BIT AND SPUR WOODS SUBDIVISION,
RESUBDIVISION OF LOT 4

APPLICATION NUMBER 17 DATE February 18, 2010

REQUEST Subdivision

DETAIL SITE PLAN

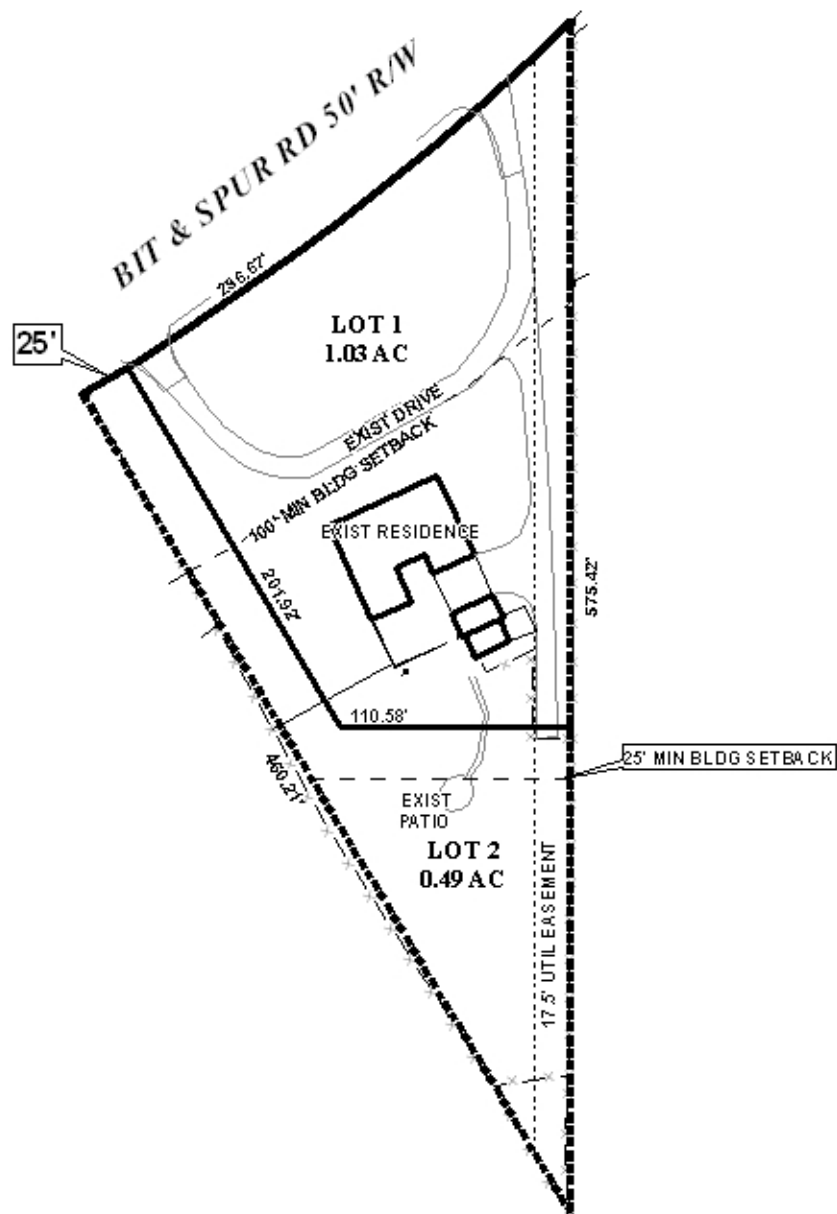
The site fronts onto Bit and Spur Road which currently has a compliant 50' right-of-way; therefore, no dedication would be required. As a means of access management, a note should be required on the final plat stating that each lot is limited to one curb cut to Bit and Spur Road, with the size, location and design of each curb cut to be approved by Traffic Engineering and conform to AASHTO standards.

The plat illustrates the current 100' minimum building setback line along Bit and Spur Road for proposed Lot 1, and this should also be shown on the final plat. Also, for proposed Lot 2, the 25' minimum building setback line is illustrated as being measured from all parts of the proposed new East-West interior lot line, and this should also be illustrated on the Final Plat. Each lot is labeled with its size in square feet and acres and this should also be done on the Final Plat, or a table should be furnished on the Final Plat providing the same information.

- 1) placement of a note on the Final Plat stating that each lot is limited to one curb cut to Bit and Spur Road, with the size, location and design of each curb cut to be approved by Traffic Engineering and conform to AASHTO standards;

- 2) illustration of the current 100' minimum building setback line along Bit and Spur Road for Lot 1;
- 3) illustration of the 25' minimum building setback line for Lot B as measured along the entire length of the new East-West interior lot line;

- 4) labeling of each lot with its size in square feet, or the furnishing of a table on the Final Plat providing the same information;
- 5) placement of a note on the final plat/site plan stating that approval of all applicable Federal, state and local agencies for endangered, threatened or otherwise protected species is required prior to the issuance of any permits or land disturbance activities; and
